BIDDING RFI LOG

Lander University Wellness Clinic

PROJECT # 25003

LANDER WELLNESS CENTER RENOVATION
STATE PROJECT - H21-9572-TM
CONTRACTOR:

AD1.01

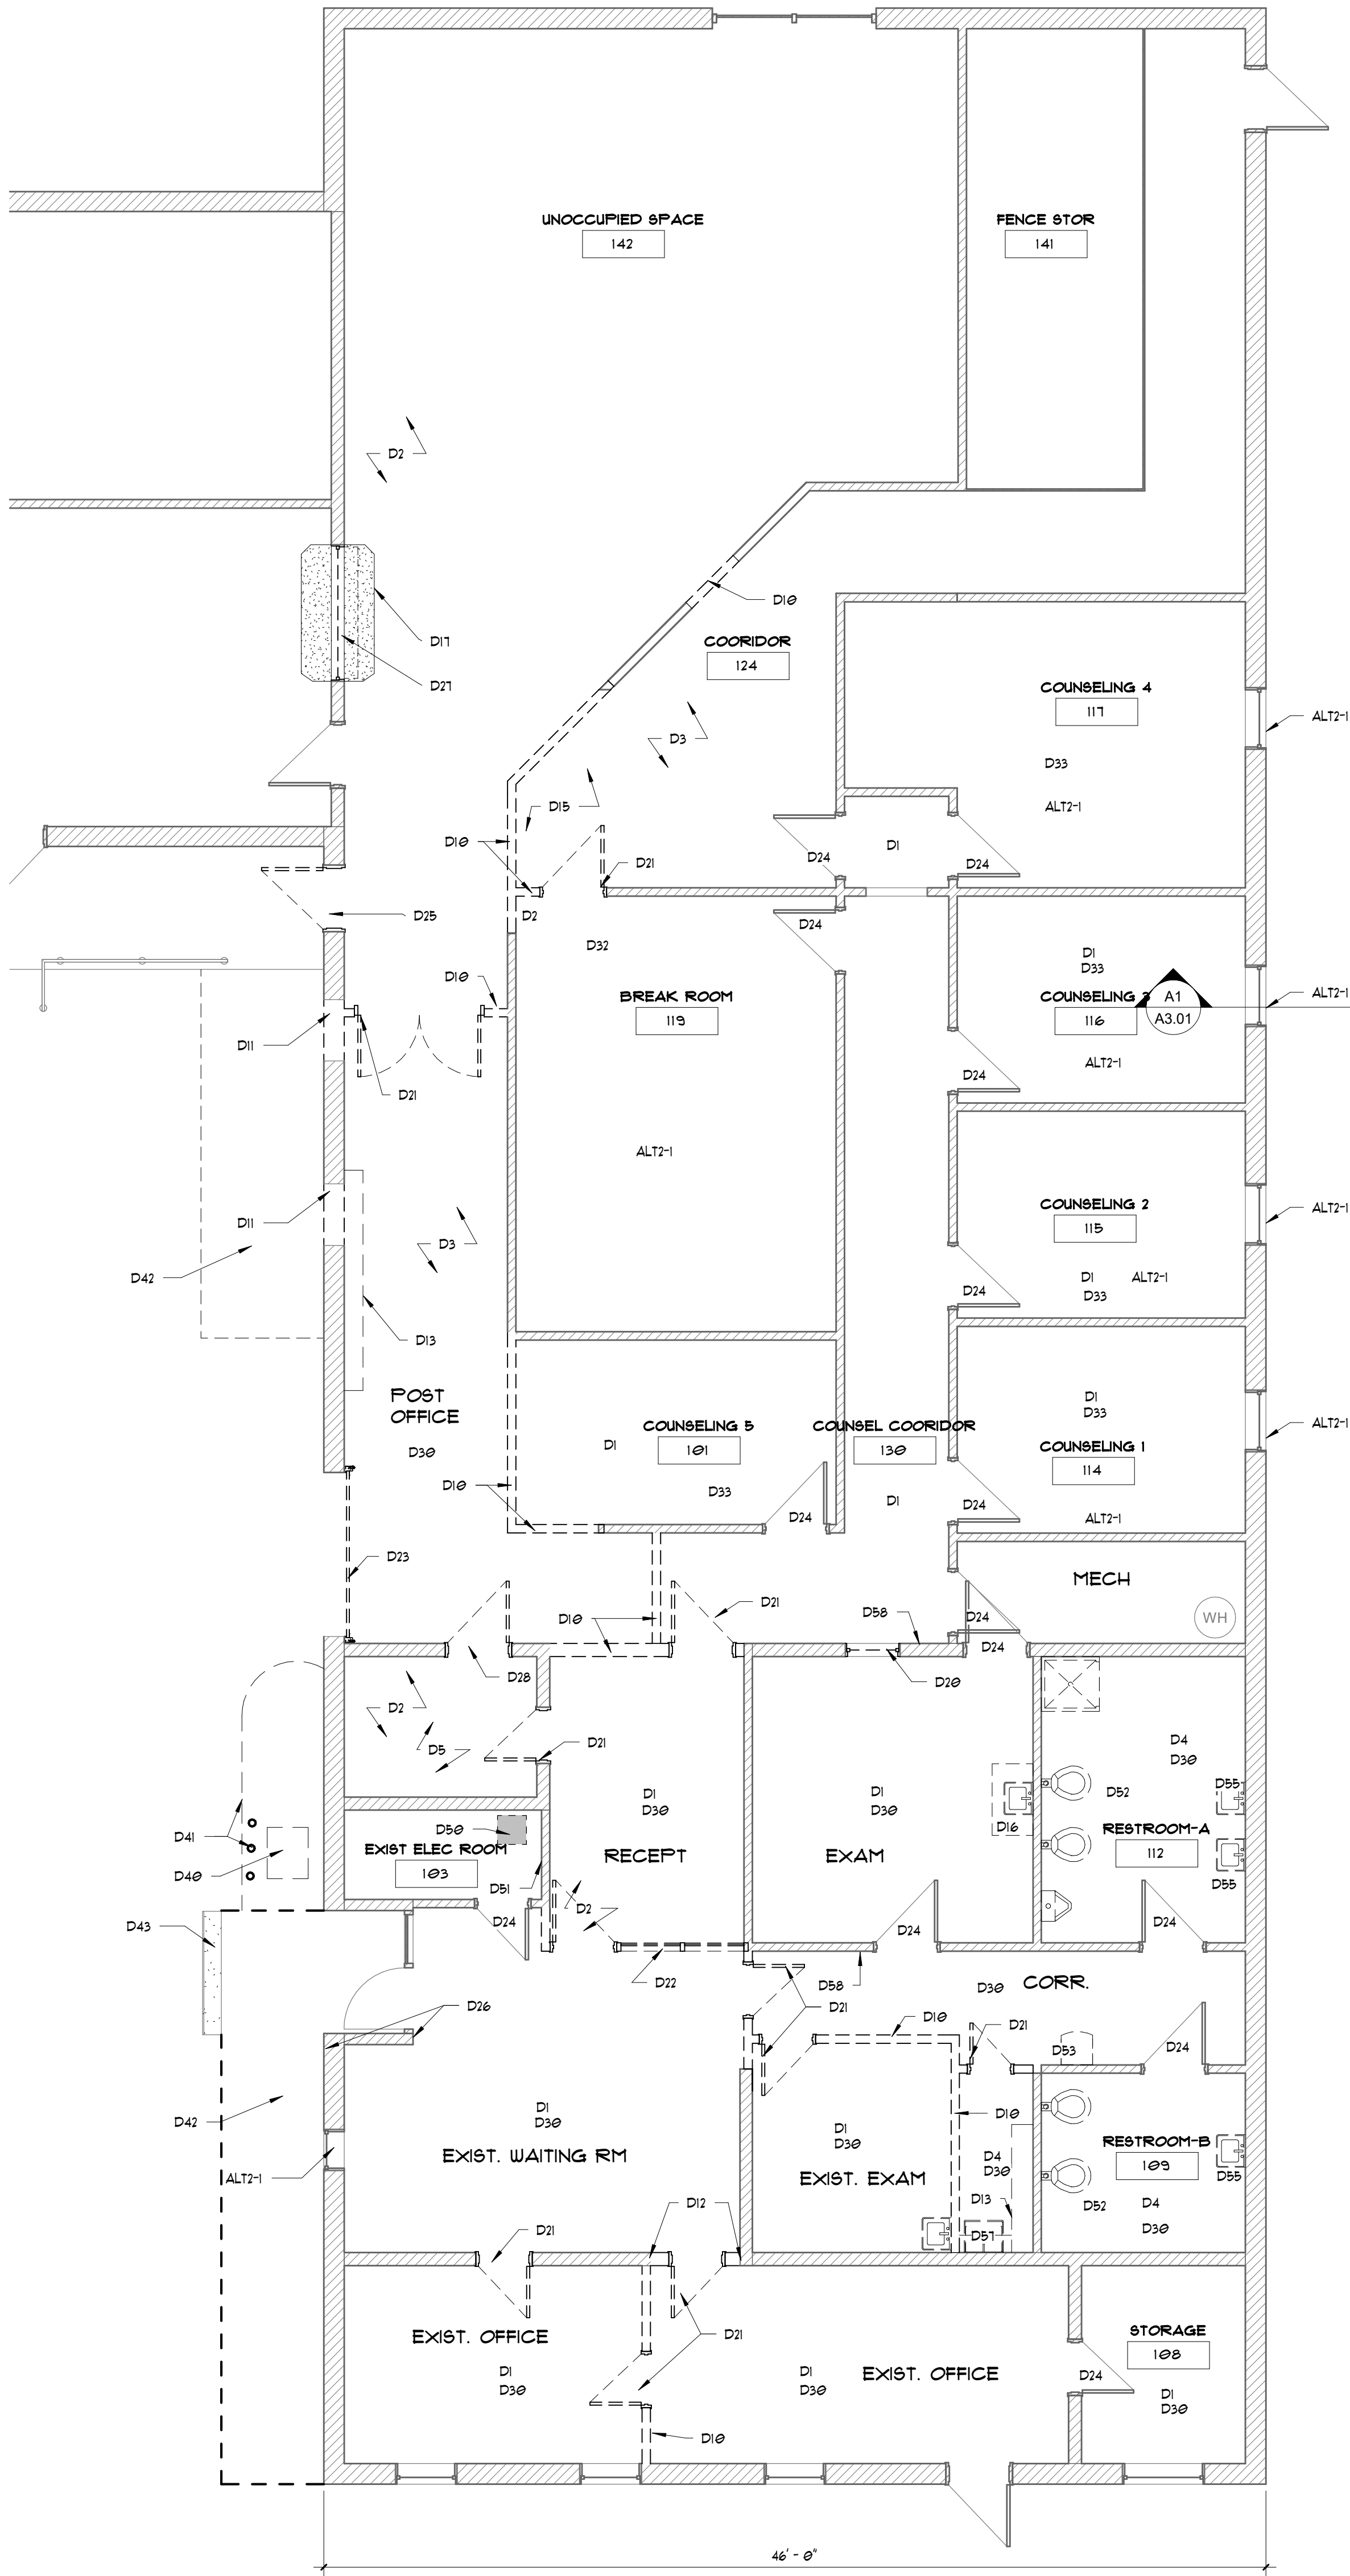
RFI #	QUESTION	SHEET NUMBERS	DISCIPLINE	DATE RECVD	DATE RESPOND	RESPONSE
9	Will there be any landscaping replacement based on the new ramp?	Site	Arch	10/2/26	10/5/26	Area is all hardscape outside of planter bed next to ramp being removed. Any plants damaged in this area should be replaced.
10	What subcontractor currently services your IT?		Lander	10/2/26	10/5/26	Internal Staff to Lander, Network Controls has previously worked on campus as well
11	Please clarify what D5 refers to as shown in the room next to the electrical room.	AD1.01	Arch	10/2/26	10/5/26	Existing Floor in exposed concrete, prep slab and existing drain for tile flooring.
12	Is there a percentage we should include for the replacement ceiling tiles, D33?	AD1.01	Arch	10/2/26	10/5/26	That would be a means and methods of site management
13	Please clarify whether D12 is used, it is not shown on the drawings.	AD1.01	Arch	10/2/26	10/5/26	Wall Between exist. Waiting room and exist office is assumed to be CMU wall.

14	Please clarify whether D14 is used and if we need to salvage any FECs.	AD1.01	Arch	10/2/26	10/5/26	Duplicate note, Follow D58. We observed (2) FEC to be salvaged
15	Please confirm we are to demo the existing grid and tile in the corridor at the existing restrooms and the room plan N of the existing electrical room, these are not noted on the demolition plan.	AD1.01	Arch	10/2/26	10/5/26	Grid and Tile to removed in those corridors (D30)
16	Please confirm where we are removing the ACT tiles and protecting the grid, D31.	AD1.01	Arch	10/2/26	10/5/26	Disregard demo note D31
17	Will Lander University be responsible for all telephone, IT, AV, and IS infrastructure relocation?	AD1.01	Lander	10/2/26	10/5/26	Lander University will relocate IT equipment, GC to provide back box and conduit pathways.
18	Is there a warranty on the EIFS?	AD1.01	Lander	10/2/26	10/5/26	No
19	Should door number 124C be replaced with 124D?	A1.01	Arch	10/2/26	10/5/26	124C is the rear exterior egress door that needs new hardware. 124D will be replaced in Phase 2.

A2.01

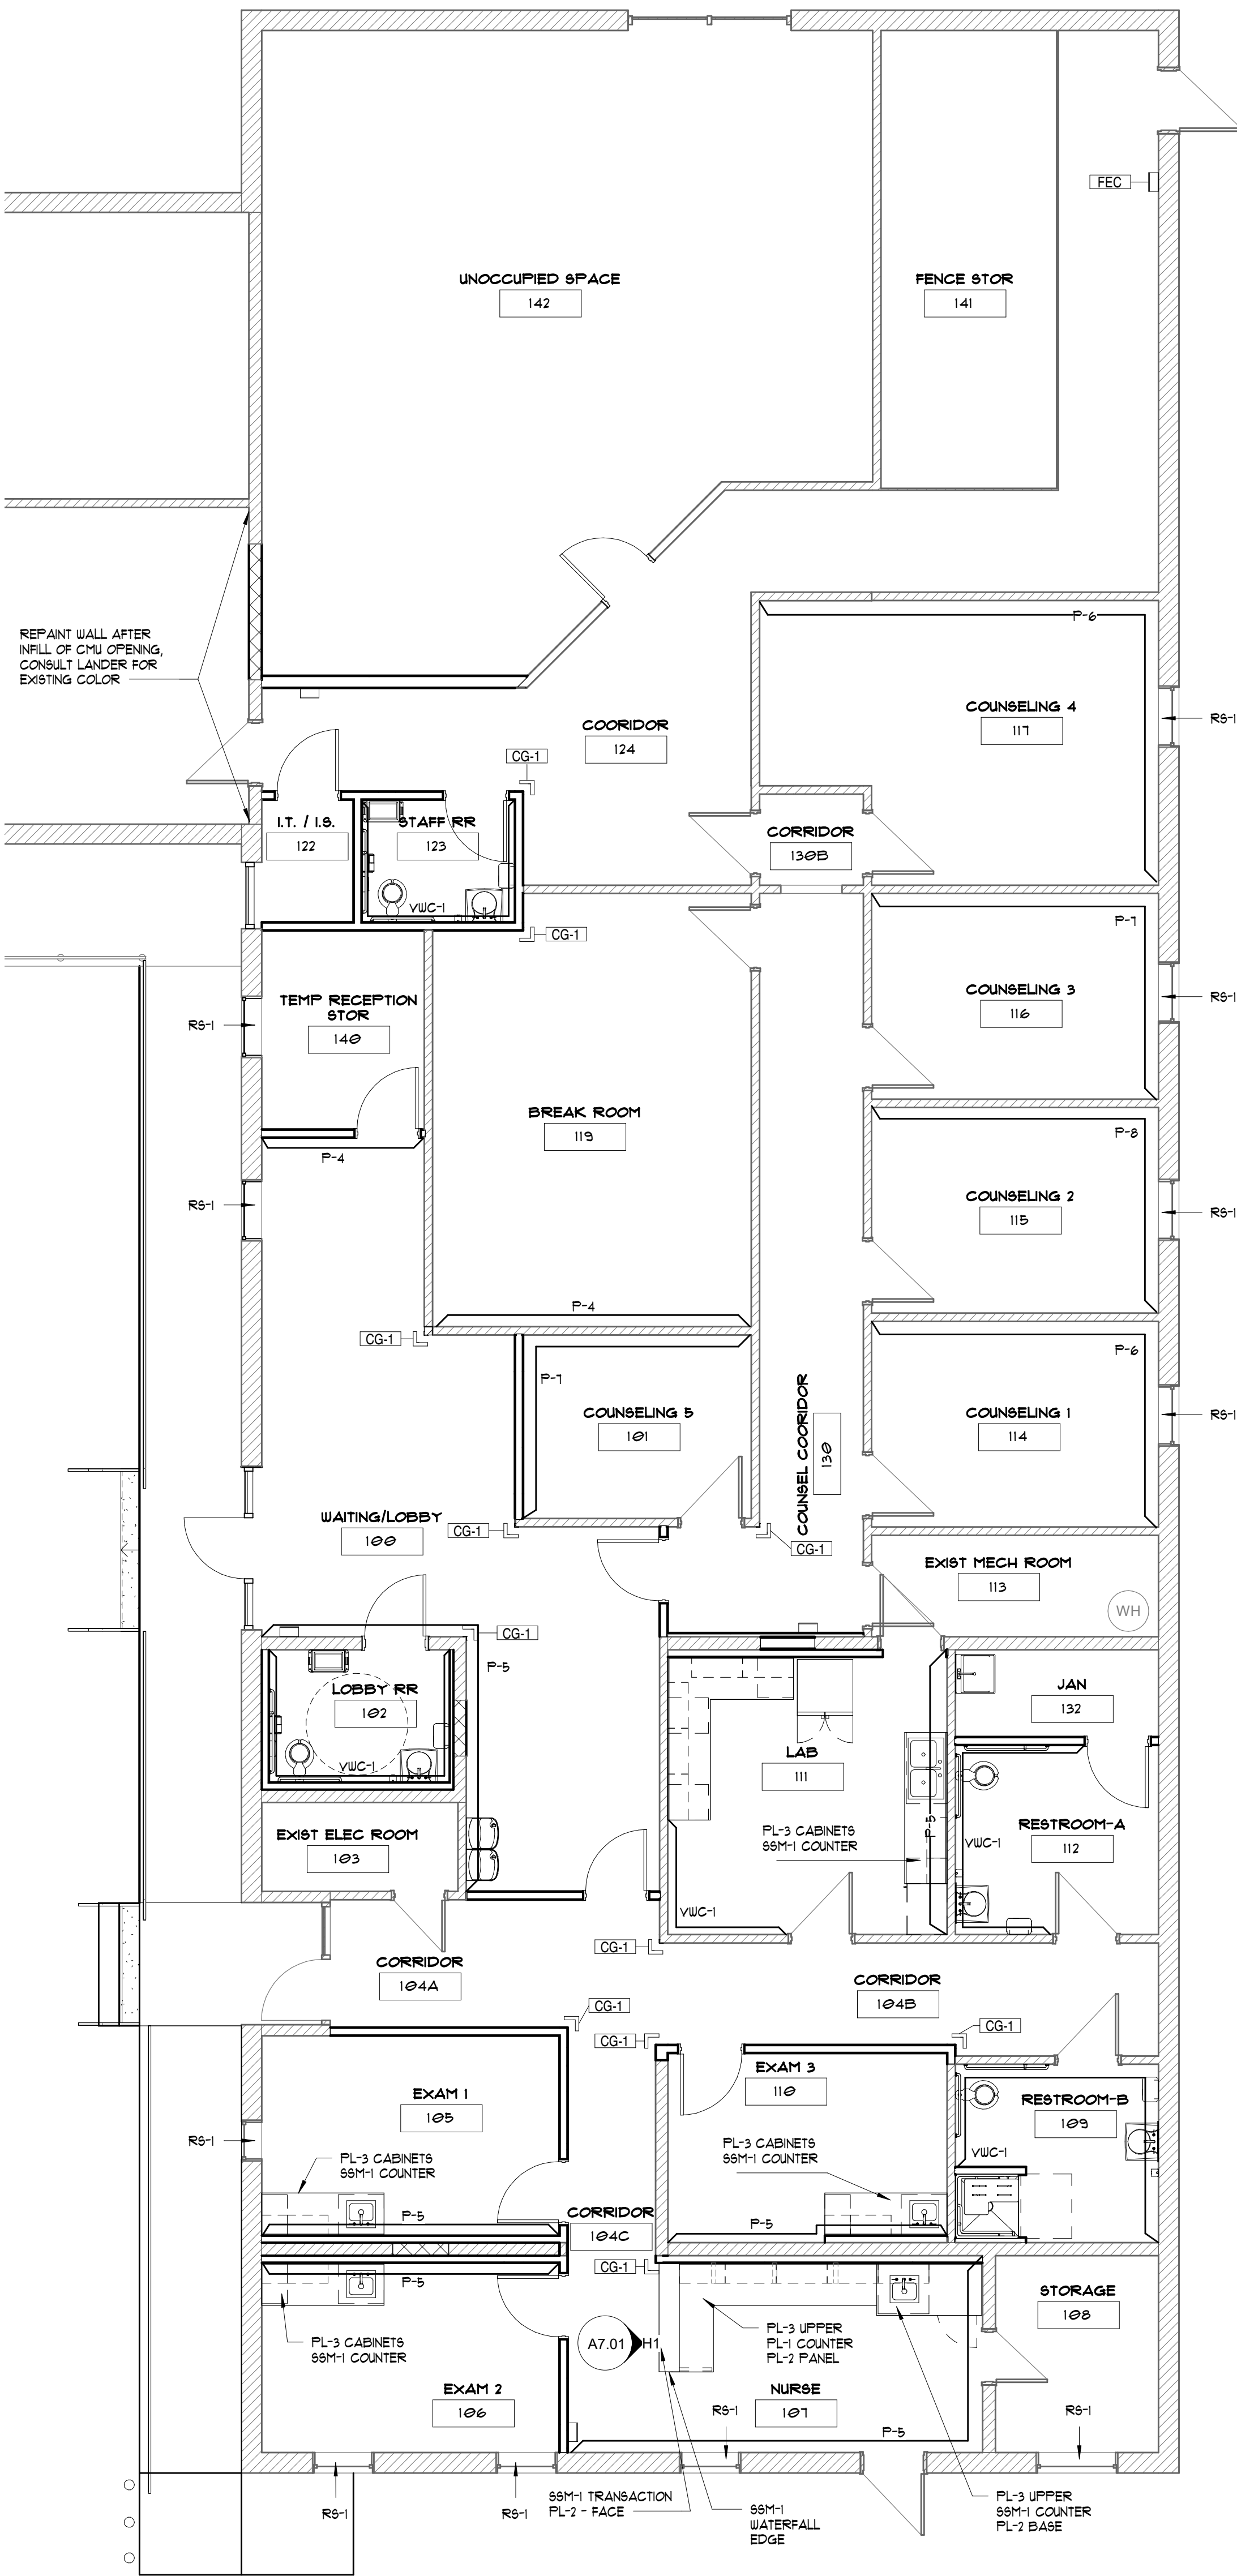
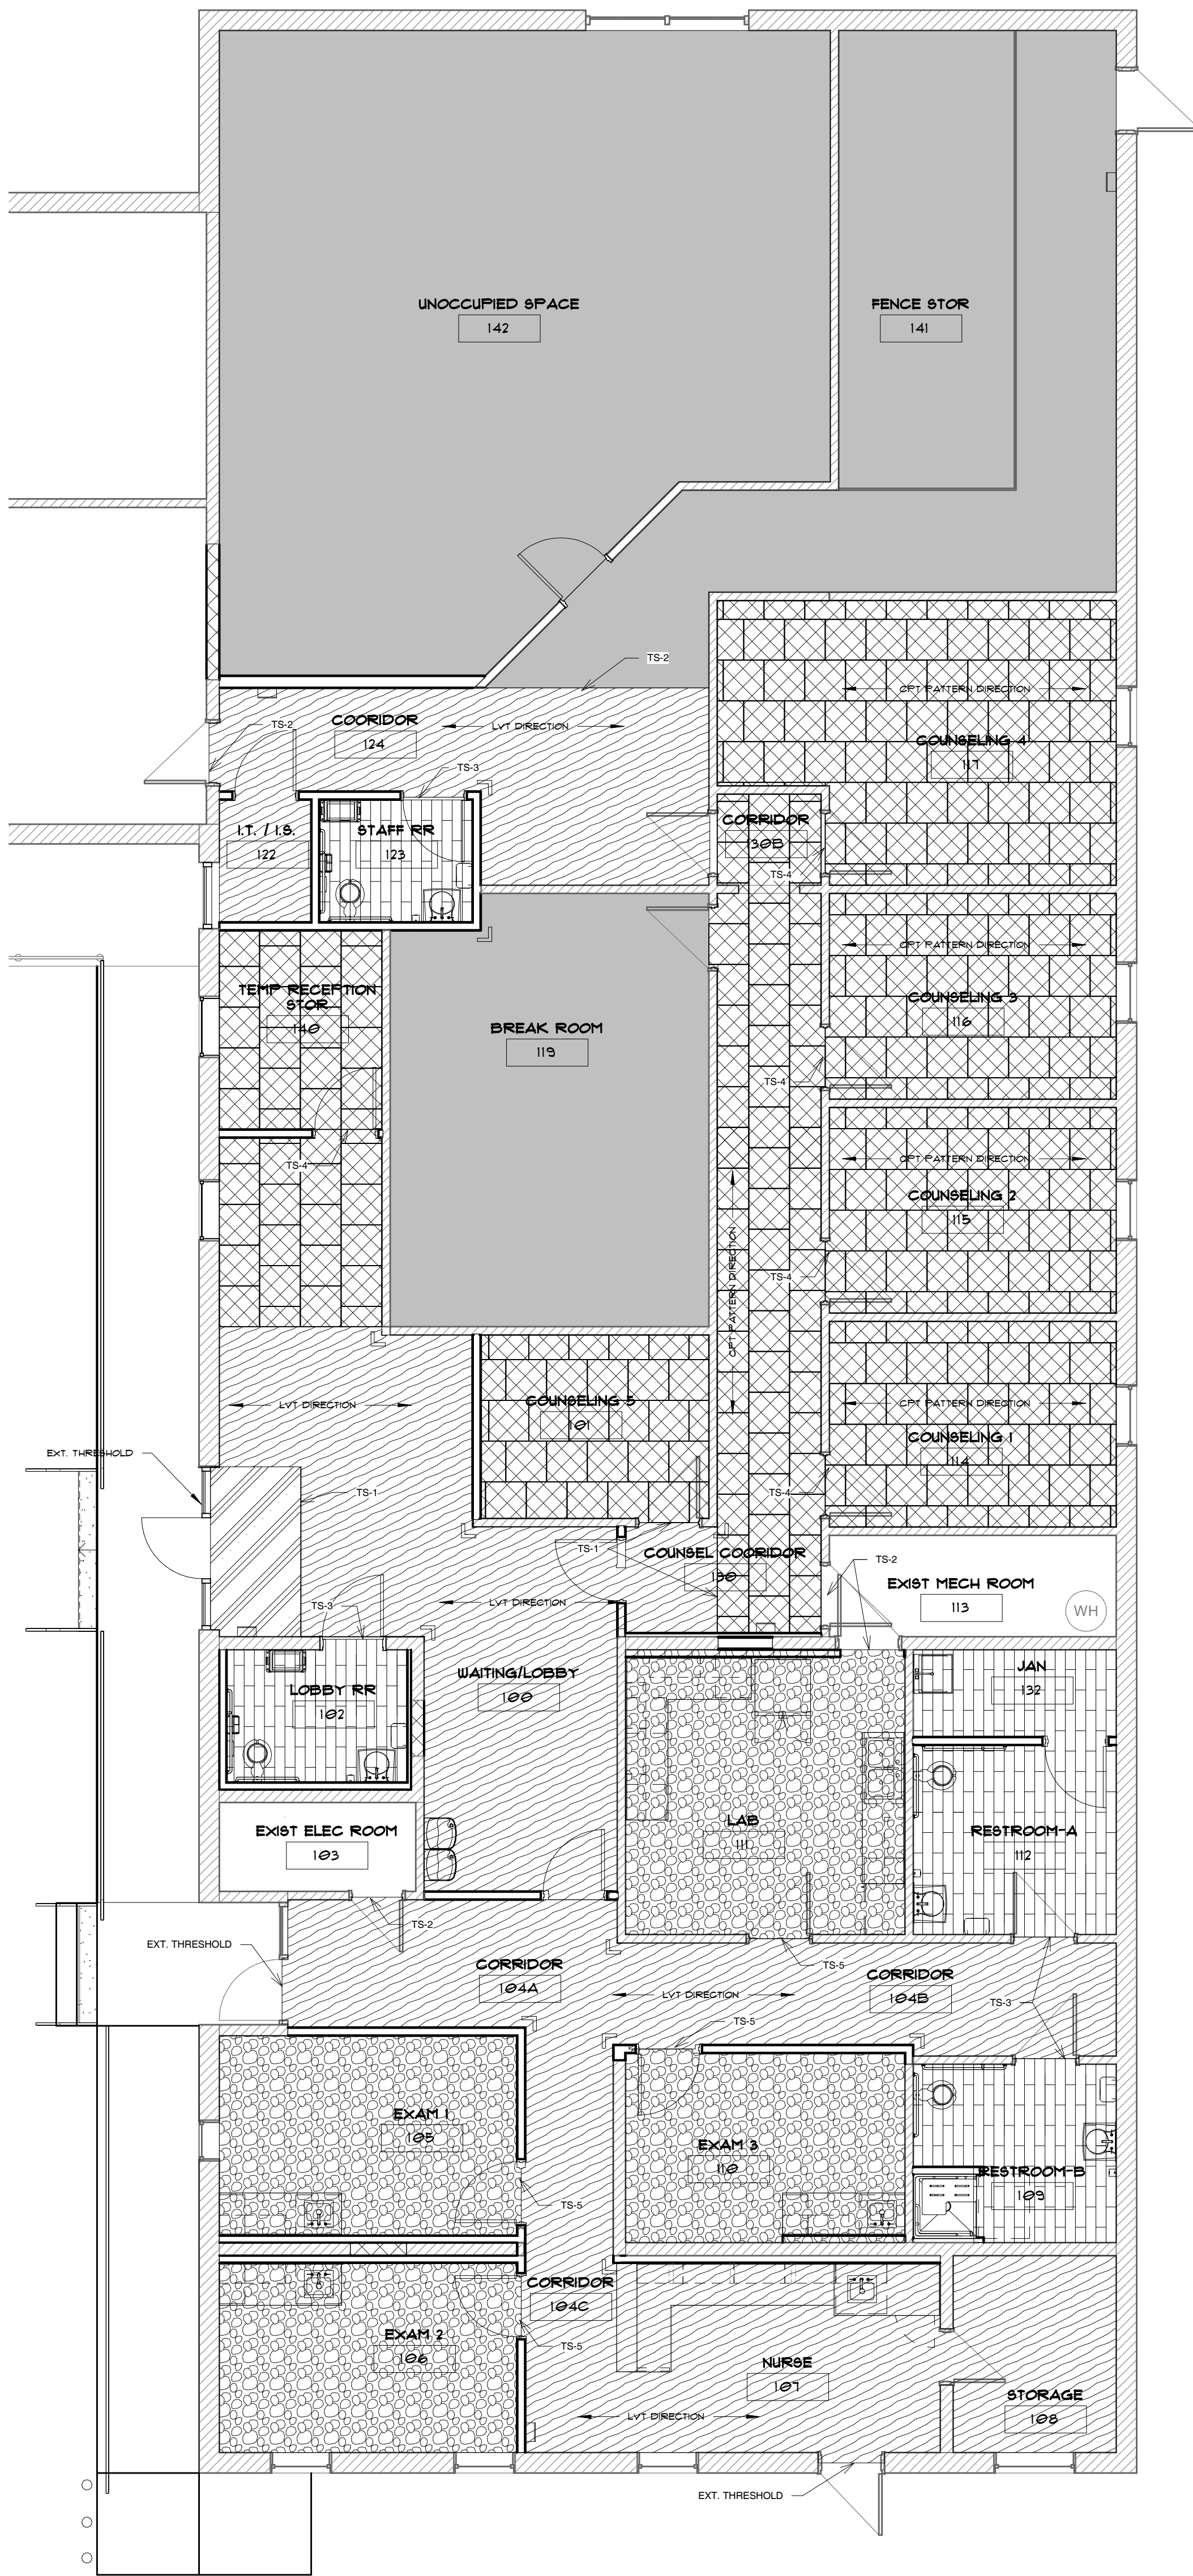
RFI #	QUESTION	SHEET NUMBERS	DISCIPLINE	DATE RECVD	DATE RESPOND	RESPONSE
1	The finish schedule calls out LVT-1, LVT-2 as well as CPT-1, CPT-2 how-ever there is no distinction as to which room gets what. Please advise	A2.01	Arch	9/29/26	10/5/26	Finish Schedule Updated. LVT-1, LVT-2, CPT-1, and CPT-2 specs called out on Finishes Legend
2	Who is to move the IT equipment currently located in the future lobby restroom 102?		Lander	10/2/26	10/5/26	Lander University will relocate IT equipment
3	Please advise on sprinkler head located in janitor closet located in-between restroom 108 and exam room.		Plumbing	10/2/26	10/5/26	Sprinkler system is abandoned and this head and branch pipe can be removed.
4	Add alternation demolition keynotes on AD1.01. Please verify alternate numbers listed on plans.	AD1.01	Arch	10/2/26	10/5/26	Disregard Add Alt #2 - "Demo Ceiling in Counselor Offices". Removing existing windows should be Add Alt #2

RFI #	QUESTION	SHEET NUMBERS	DISCIPLINE	DATE RECVD	DATE RESPOND	RESPONSE
20	There are conflicts between the Floor Finish Plan, the Finish Schedule, and the Legend. Please confirm which plan or schedule we should follow.	A2.01	Arch	10/2/26	10/5/26	Finish schedule has been updated to match finish floor plan.
21	Will all existing furnishings be removed by owner?		Lander	10/2/26	10/5/26	Yes
22	Who is to provide and install the ice machine, UC fridge, and water box in the Nurse room?	A7.01	Plumbing	10/2/26	10/5/26	Ice Machine and UC Fridge to be OFCI, Water Supply box to the CFCI
23	Please confirm window shades are only included as Alternate 2 and there will not be shades at the windows to be installed in Phase I.	A3.01	Arch	10/2/26	10/5/26	All windows to receive roller shades, updated on finish plan. (11) windows according to our count.
24	ED1.01 shows the exterior wall pack to be removed and on A3.01 it is noted as existing to remain. Please advise what needs to be done.	ED1.01	Elec	10/2/26	10/5/26	Wall Pack to be removed and replaced with new fixture
